**Re: The Bluffs at Encantado Subdivision, SIA/Financial Guarantee Release
Engineer's Stamp dated 8-04-06 (K23-D27)
Certification dated 7-03-07**

**Re: The Bluffs at Encantado Subdivision, Preliminary Plat
Engineer's Stamp dated 6-18-06 (K23-D27)**

DRAINAGE REPORT
FOR
THE BLUFFS AT ENCANTADO
SUBDIVISION

**Re: The Bluffs at Encantado Subdivision, Preliminary Plat
Engineer's Stamp dated 5-05-06 (K23-D27)**

AVITAL COURT NORTH OF HUERFANO

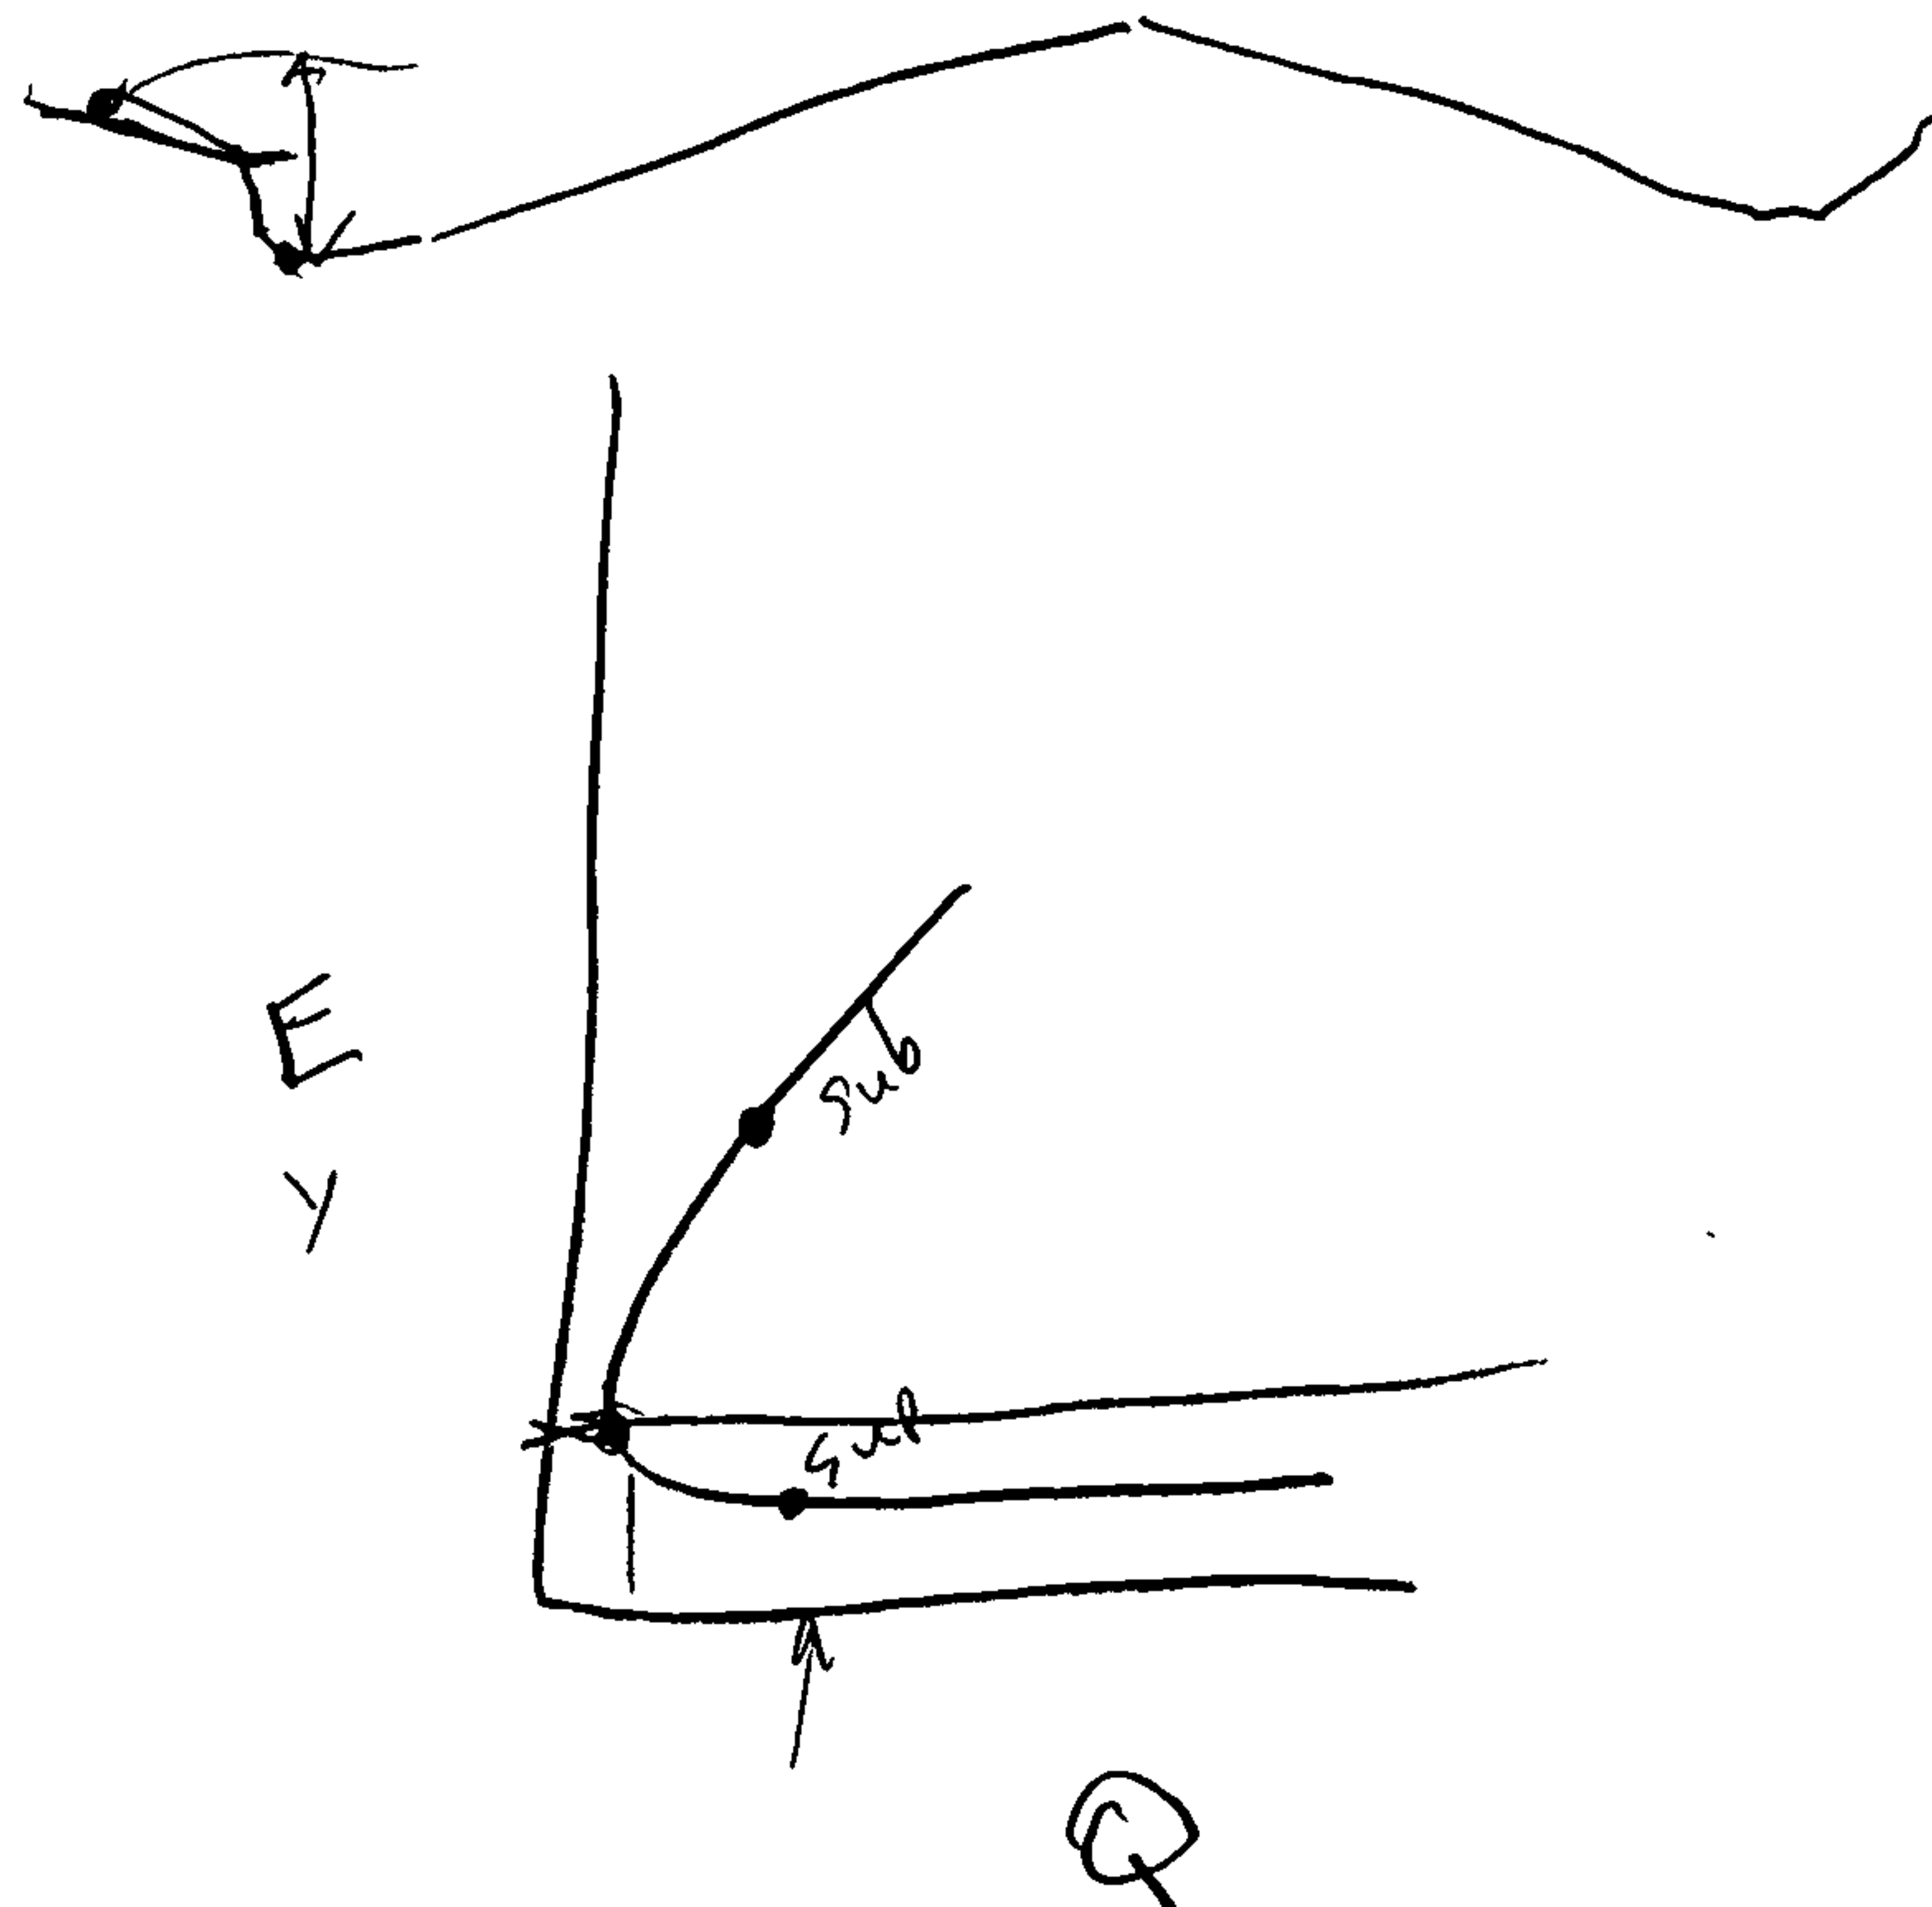
super-critical

PUBLIC ACCESS ROW NORTH OF SKYLINE

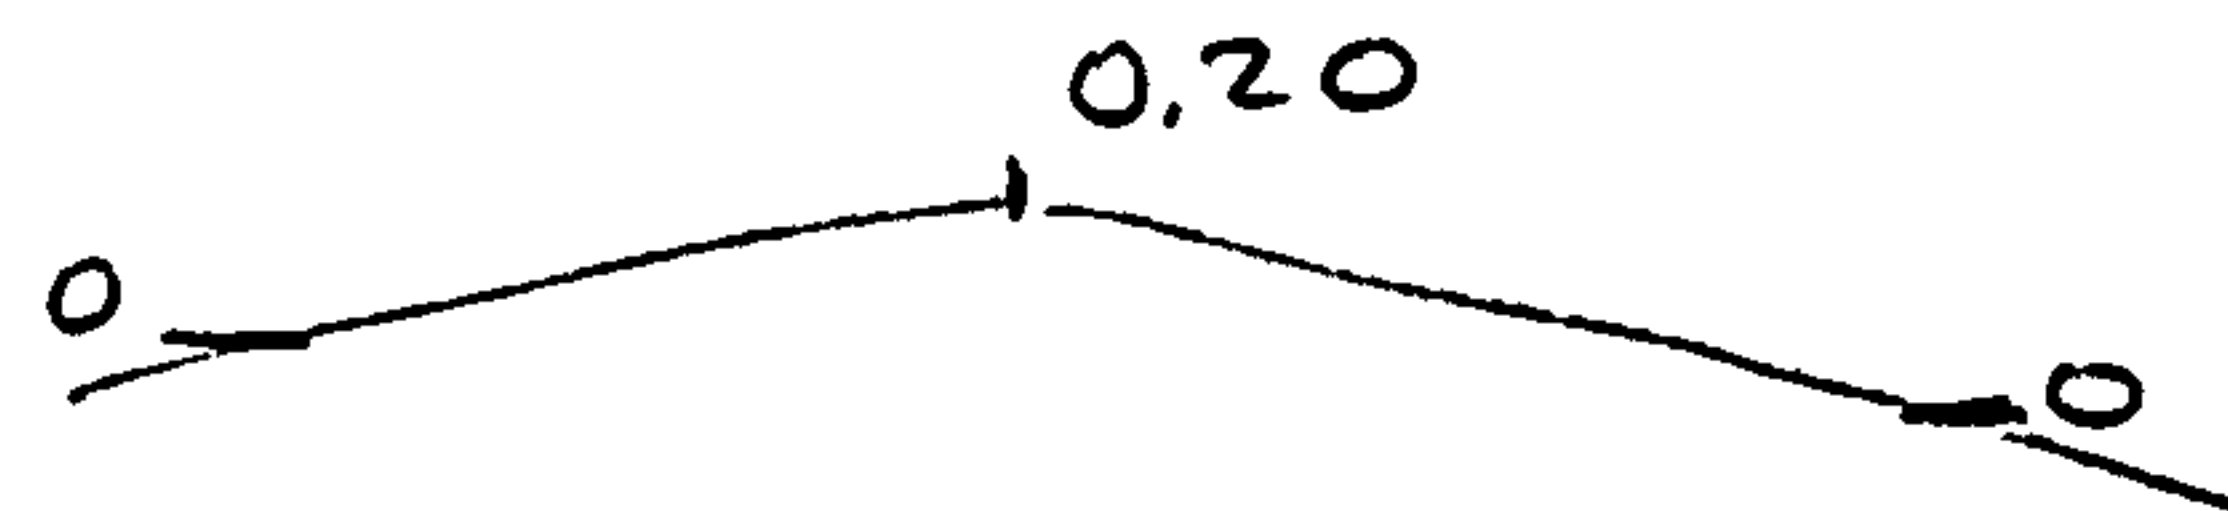
3. More information (including capacity calculations) must be provided for the proposed backyard ponds.
4. The worksheet provided for the public access right of way north of Skyline needs to be done assuming a 17-foot pavement width, not an 18-foot width. In addition, please be aware that using a height of 0.67 feet in your channel calculations precludes the use of mountable curb in this area.

Sequent
 Depth = 0.53'
 for 4" mountable
 curb & gutter
